**HARTZELL PROPELLER INC.**  
**SERVICE BULLETIN**  
**HM-SB-001**

**Hovercraft Propellers -  
Hub/Blade Identification and Component Replating**

**103015 Mounting Flange Cylinder Replating  
Figure 1**

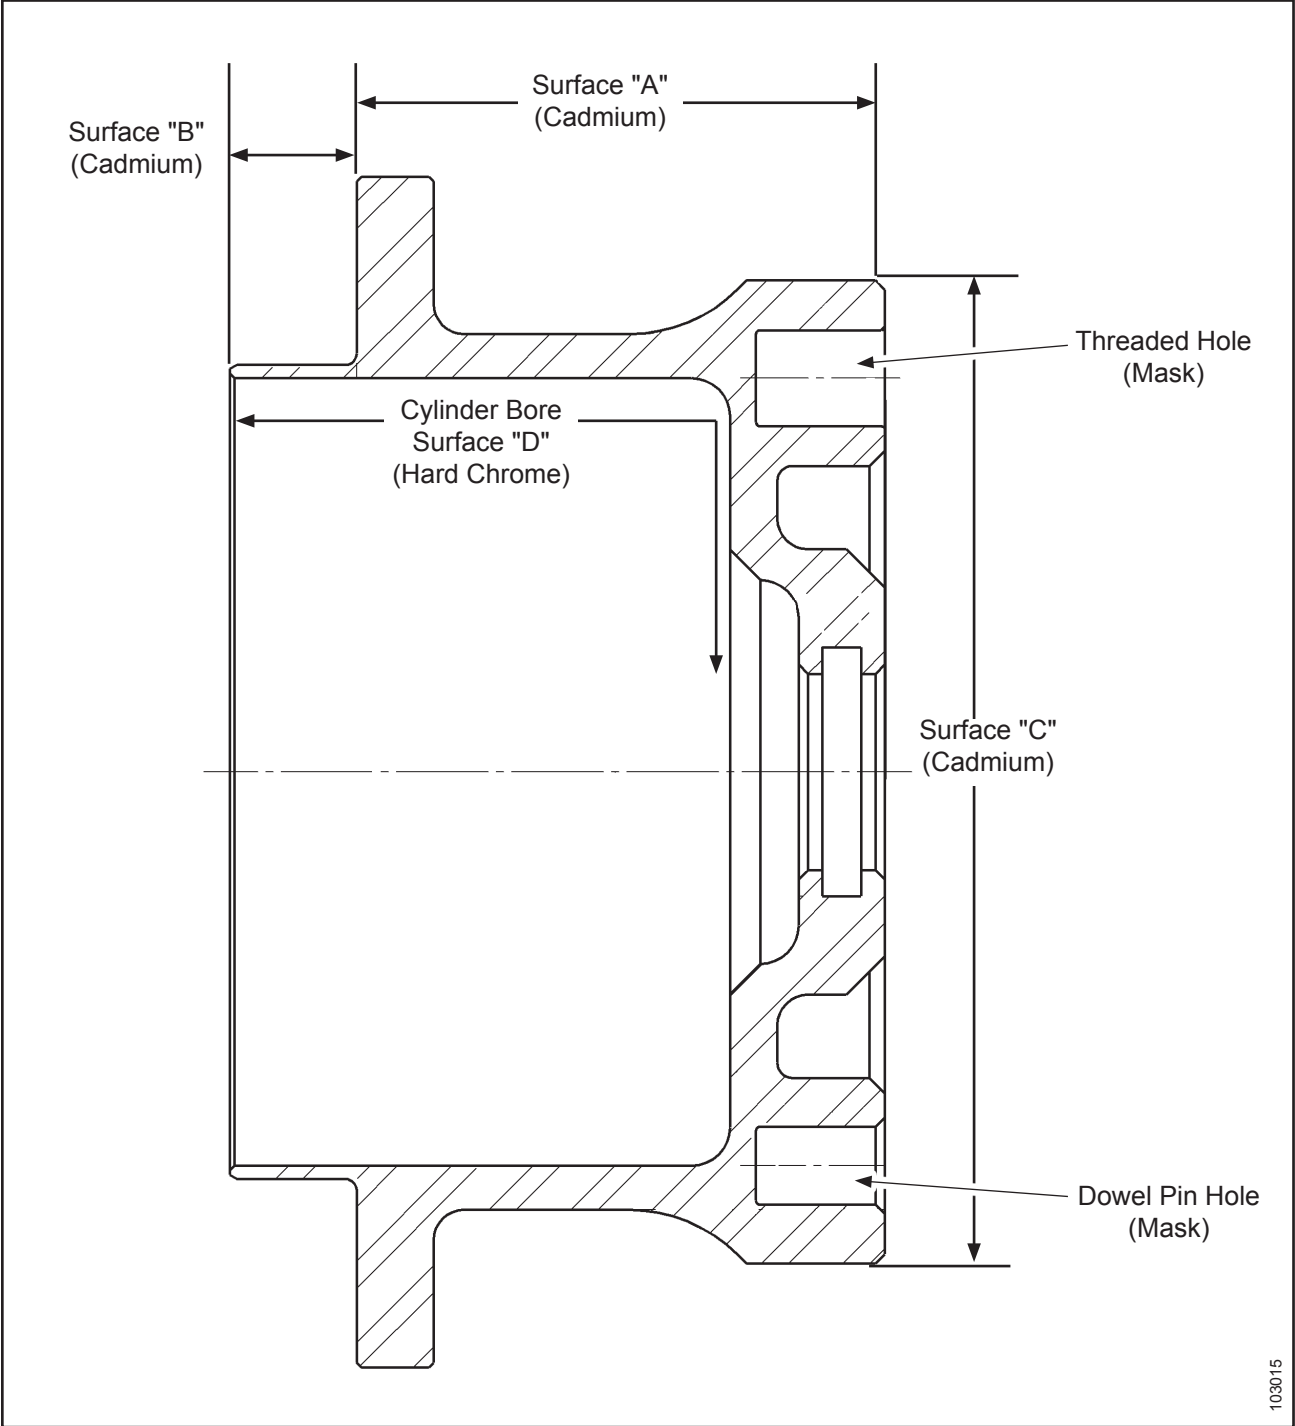
- (3) 103015 Mounting Flange Cylinder - Refer to Figure 1
  - (a) Remove nickel plating in accordance with the Accomplishment Instructions in this Service Bulletin.

- (c) Mask all threaded holes and dowel pin holes.
  - (d) Apply cadmium plating to Surfaces "A", "B", and "C" and bake for a minimum of 23 hours in accordance with the Cadmium Replating chapter in Hartzell Propeller Inc. Standard Practices Manual 202A (61-01-02).

- (e) Return the 103015 Mounting Flange Cylinder to Hartzell Propeller Inc. for hard chrome plating of the cylinder bore, Surface "D".
    - 1 Contact Hartzell Propeller Inc. for part return instructions.
